**PUBLIC CODE CHANGE PROPOSAL FORM
FOR PUBLIC PROPOSALS TO THE INTERNATIONAL CODES
2012/2013 CODE DEVELOPMENT CYCLE**

R602.3.1 Tall studs

Please make the following changes to Section R602.3.1

TABLE R602.3.1
 MAXIMUM ALLOWABLE LENGTH OF WOOD STUDS EXPOSE TO WIND SPEEDS OF 100
 MPH OR LESS IN SEISMIC DESIGN CATEGORIES a,B,C,D₀,D₁, AND D₂

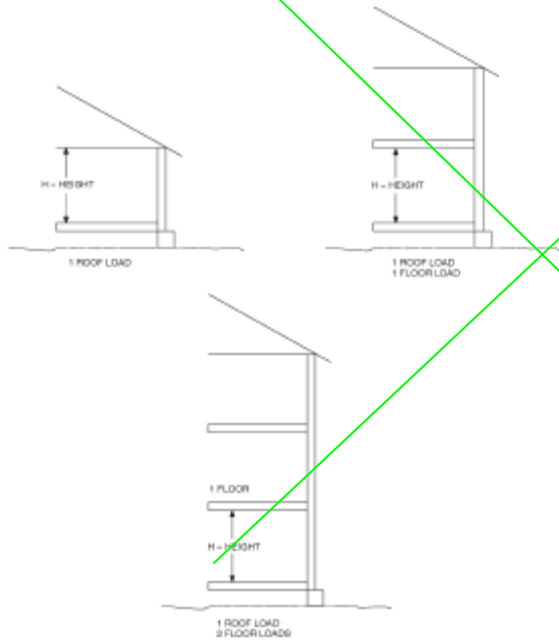
Please delete Table R602.3.1 including its related drawing.

2. ~~Studs more than 10 feet in height which are in accordance with Table R602.3.1.~~ Walls over 12 feet tall, two-story gable end walls and two-story walls supporting a roof with not more than 6' of tributary length, shall be permitted. The studs shall be 2x6 at 16 inches on center with a maximum height of 20 feet. The wall shall be sheathed with wood structural panels on the exterior and gypsum board or equivalent on the interior. Window and door penetrations shall be permitted with jack studs supporting the header in accordance with Section R602.7 and double king studs outboard of the jacks on each side of the opening.

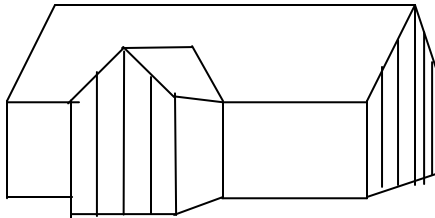
1. Eliminate the table - the source of the confusion
 2. Provide clarification as to where it can be applied (see the three options below)
 3. Write in prose the requirements using a 2x6 wall.
 4. To say that you cannot use these tall studs where the wall is an integral part of the wall bracing system.
1. It could be used for a tall wall or a two-story gable ended wall supporting nothing more than self weight.

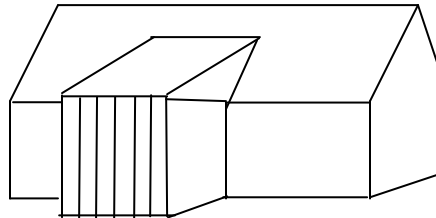
2. It could be used for a two-story projection where the roof framing runs perpendicular to the wall so long as the overbuilt roof has a trib length of 6' or less

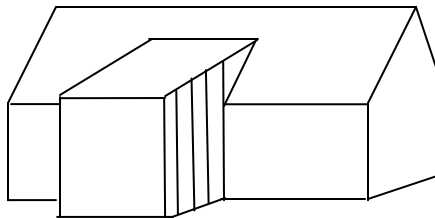
3. It could be used for a two-story projection where the roof framing runs parallel to the wall supporting nothing more than self weight
